## Land North East of Oxford Road West of Oxford Canal and East Of Bankside, Banbury, Oxfordshire

# *Technical Note: Response to Oxfordshire County Council's (Drainage) Comments* dated 12<sup>th</sup> May 2020 for Application 19/01047/OUT-2

22<sup>nd</sup> May 2020

## Drainage Strategy

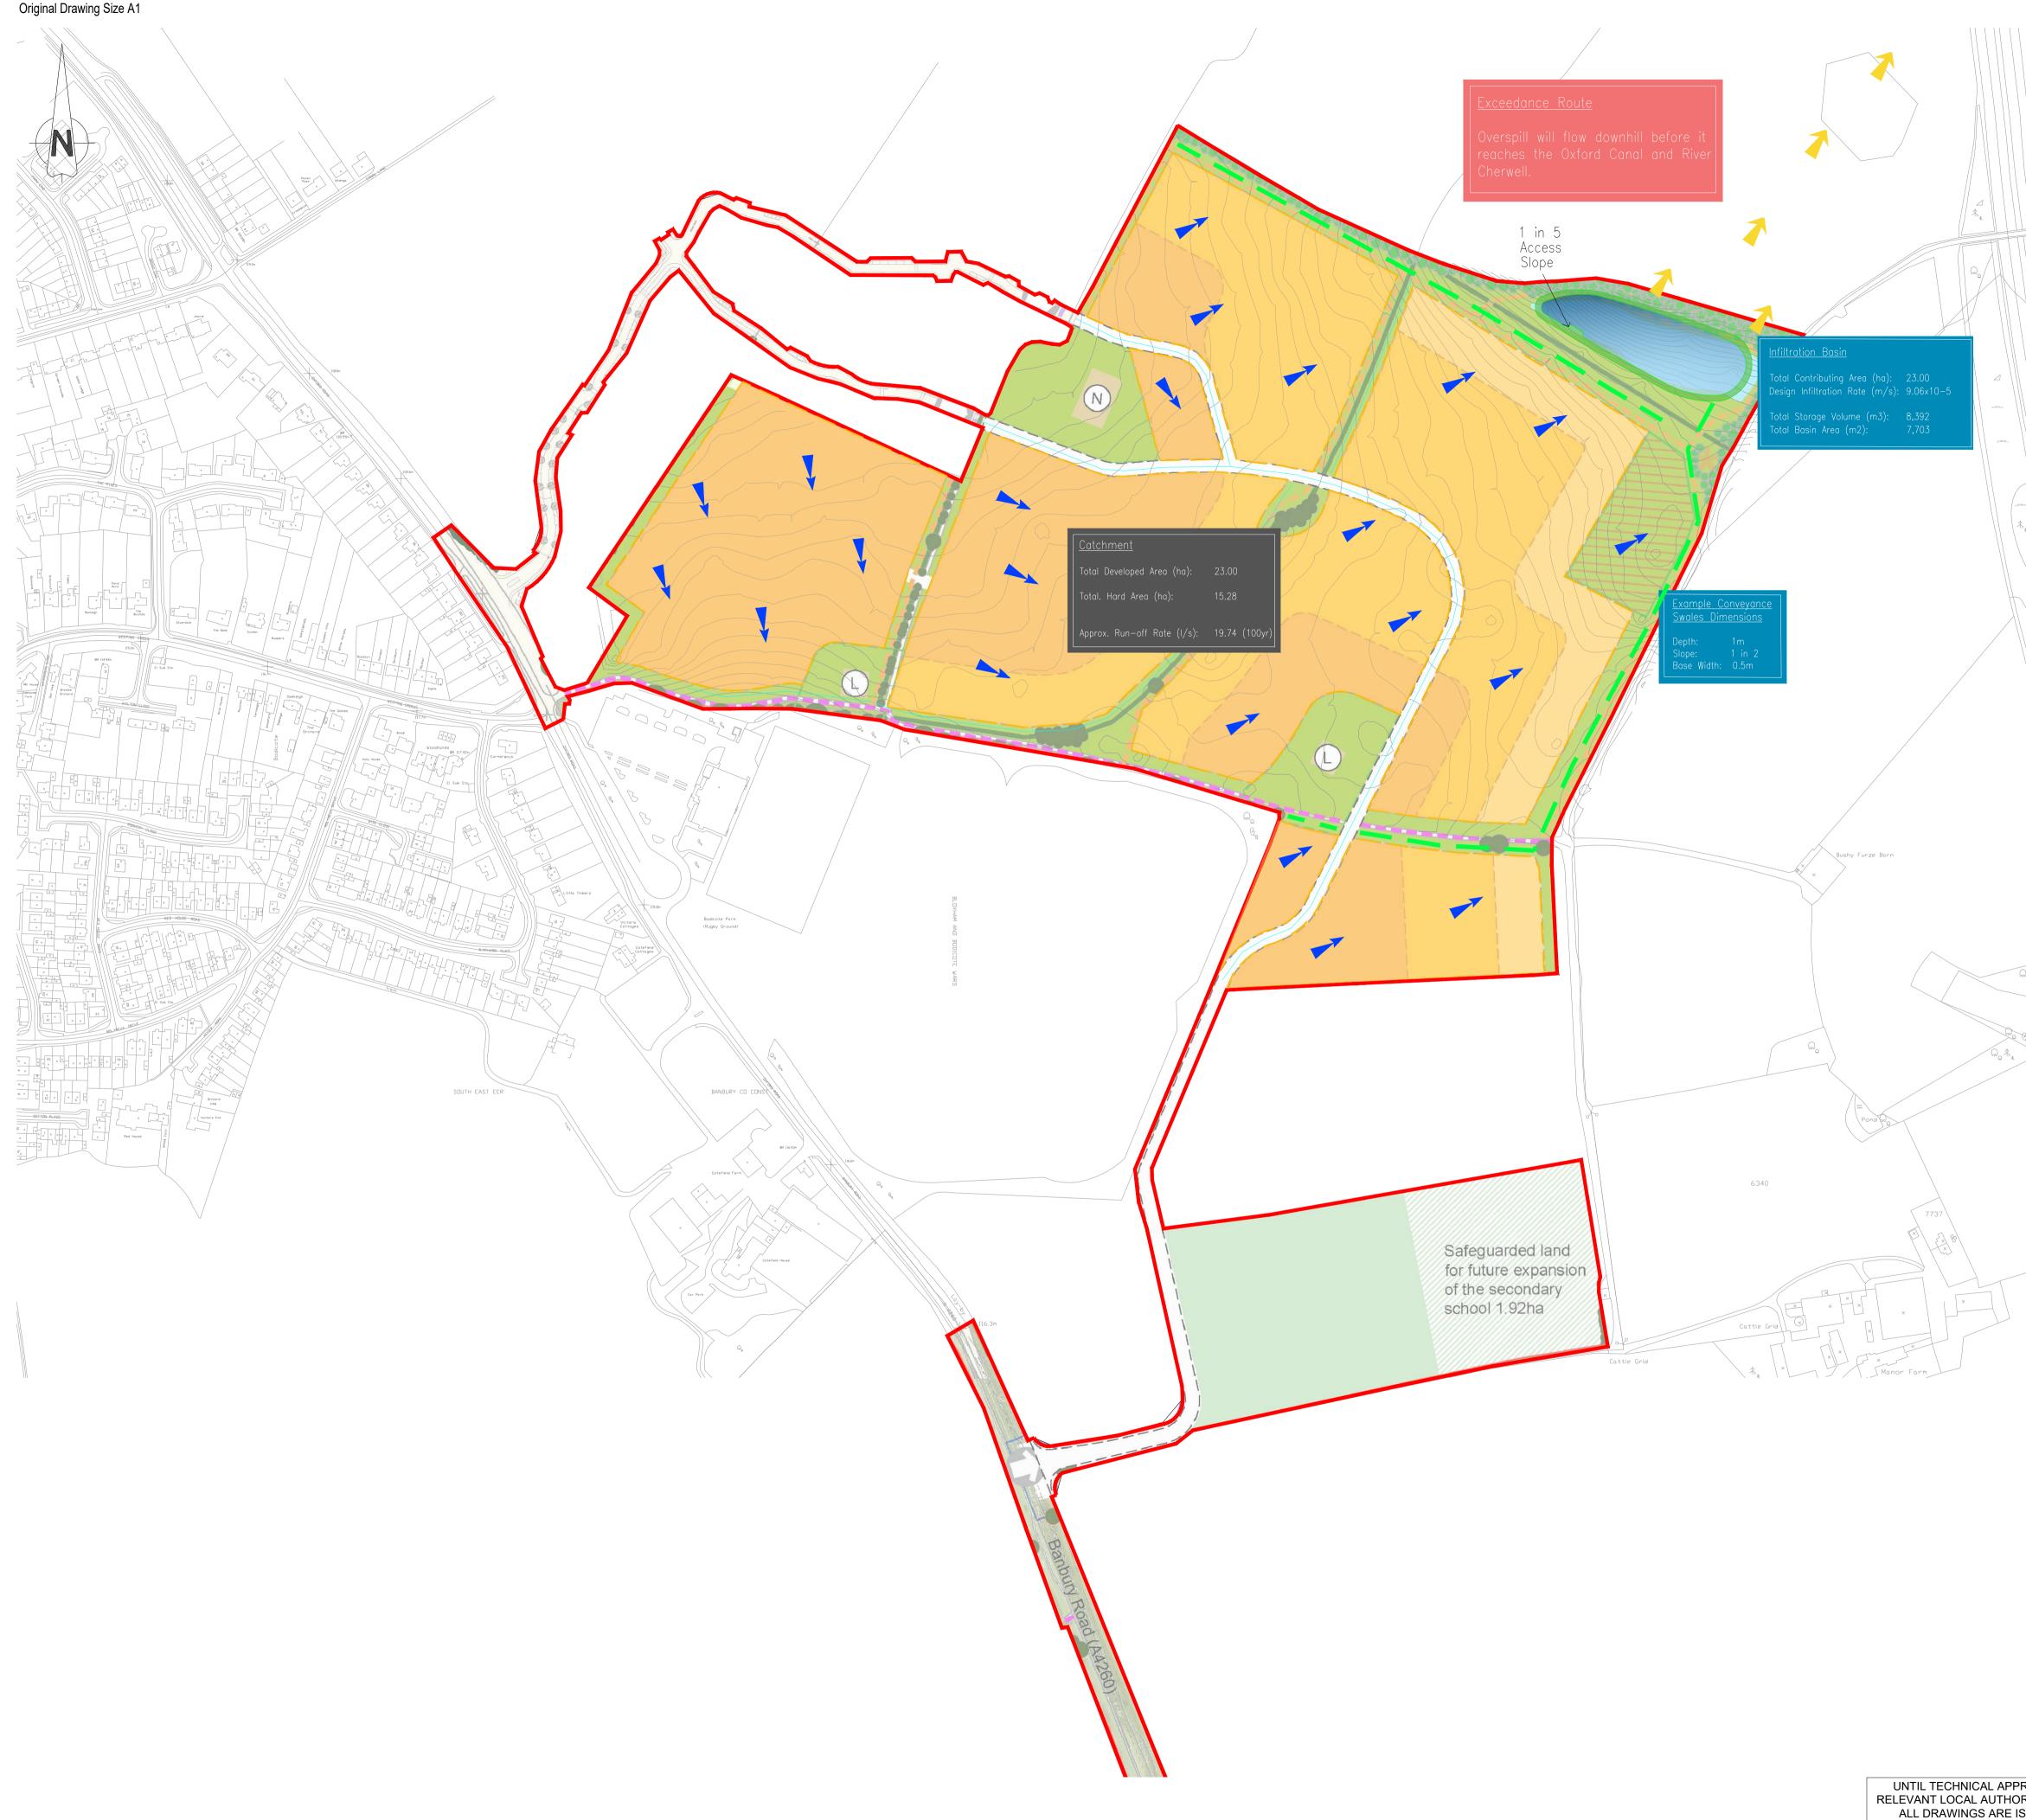
15. Safe ingress/egress needs to be demonstrated.

16. Sacrificial areas in the event of exceedance should be considered.

A maintenance slope of 1 in 5 has been illustrated on the basin shown on the updated drainage plan (DR-05 Rev F) located in Appendix A of this note.

The drainage strategy (DR- 05 Rev E), located within Appendix B of the FRA illustrates an exceedance route for storm water should the basin depth be exceeded. This is shown by the yellow arrows and the key has been amended in the subsequent revised drawing revision F in Appendix A of this note.

FEH has been used and the revised calculations are within Appendix B of this Technical Note. It should also be noted that the updated Drainage plan within Appendix A has been amended to account for FEH rainfall calculations.
